Proposed Revisions to a Standard Plans Index

Index Number: 455-154

Index Title: 54" PRECAST/POST-TENSIONED CFRP & SS
CONCRETE CYLINDER PILE

Sheet Number (s): 1 of 3

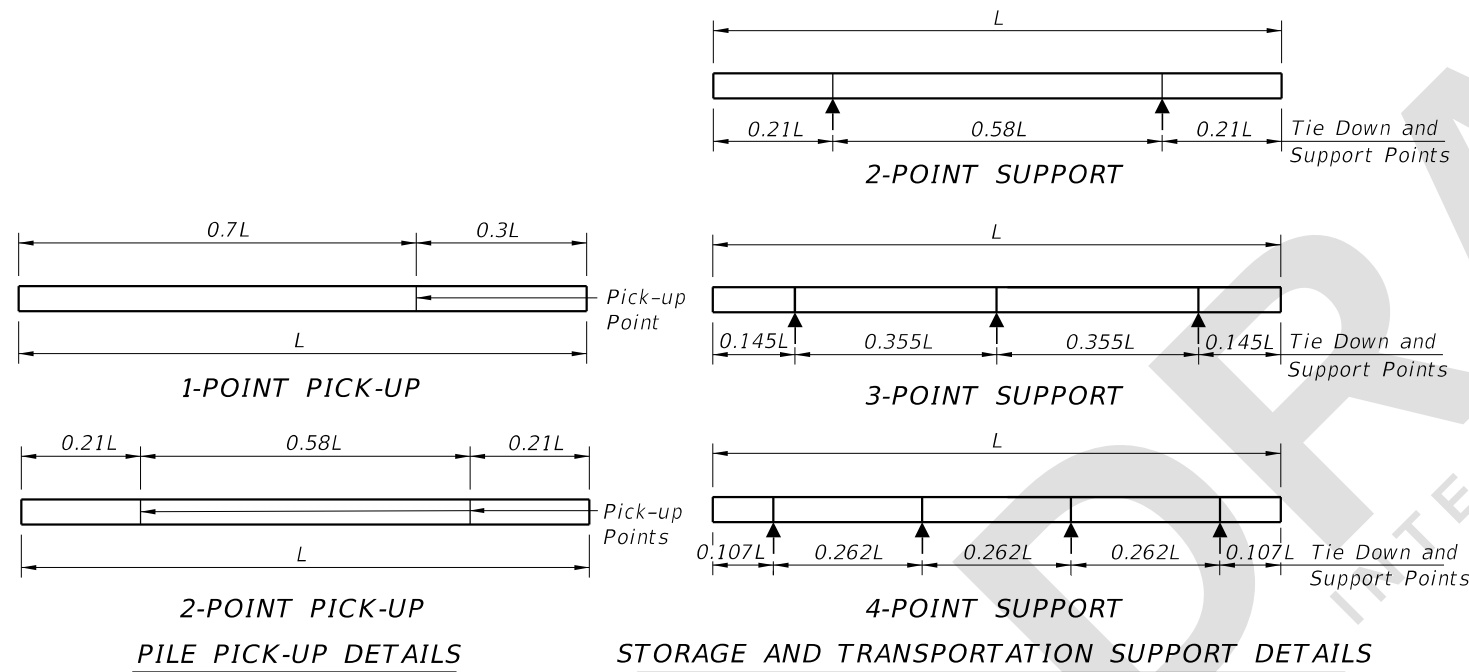
Sheet 1: Corrected note 3 language for clarity.

Sheet 1: We needed to correct the terminology so that it was clear that the value provided correlated to the application of prestressing force.

3. Concrete Strength at time of application of the prestressing force:
 - A. Piles: 6,000 psi minimum.
4. Reinforcing:
 - A. Bars:
 - a. Stainless Steel: Meet the requirements of Specification Section 931 for Type 304, Grade 75.
